SUBJECT: Forwards response to NRC 820311 request for addl info re
 low temp overpressure protection.

Subject: Oconee Nuclear Station
Docket Nos. 50-269, -270, -287

Response to NRC Request for Additional Information
Low Temperature Overpressure Protection

Figure 1

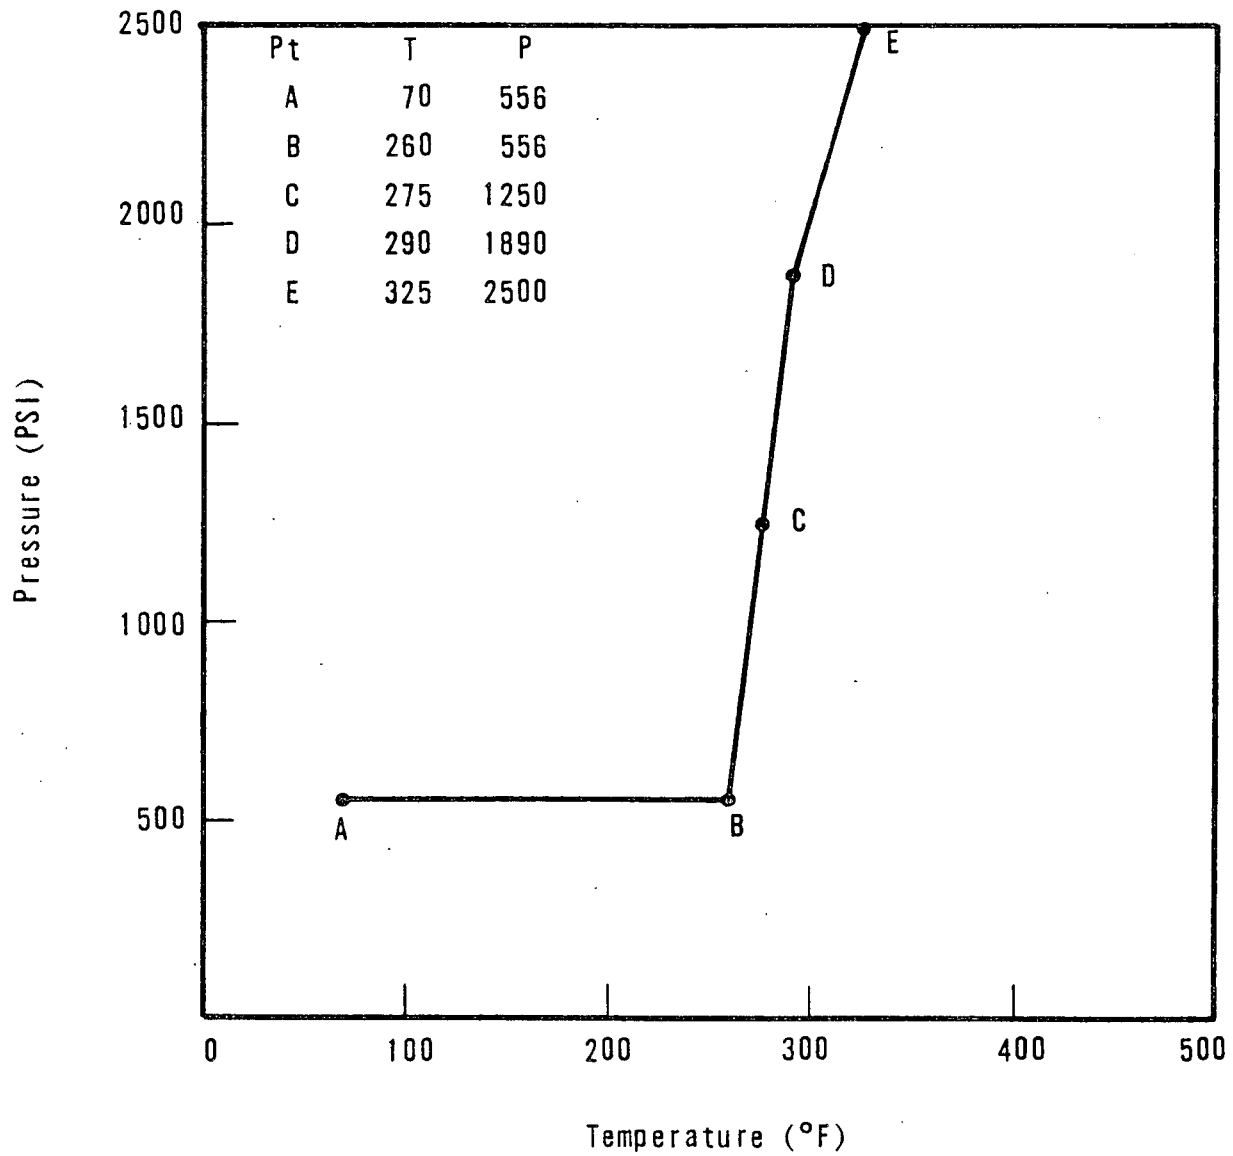
5. RSB 5-2 requires that an alarm must be provided to alert the operator that a pressure transient is occurring. You take credit for operator action to mitigate a pressure transient for all analyzed events when a failed-closed PORV is considered. No credit can be taken for operator action until 10 minutes after the operator is aware that a pressure transient is in progress. For the most severe event that you analyzed, what audible alarm will alert the operators that a pressure transient is occurring (alarms associated with the PORV cannot be used because it is assumed failed closed)? We require that acceptable technical specification changes or system modifications be proposed to increase your calculated operator time from 4.4 minutes to at least 10 minutes.

The postulated severe event is considered to be spurious opening of HP-26. This can only be postulated to occur at RC temperature conditions above 325°F. The operator has several indications that a pressurization transient is in progress. These include:

1. HP-26 not closed;
2. Pressurizer level high alarm (260");
3. HP flow in excess of normal 40-80 gpm
(An actual alarm would occur if flow was in excess of 500 gpm.);
4. RC pressure increasing (Alarmed at 2255 psig).

As can be seen with Figure 1, full system pressure is allowed for fluid temperatures above 325°F.
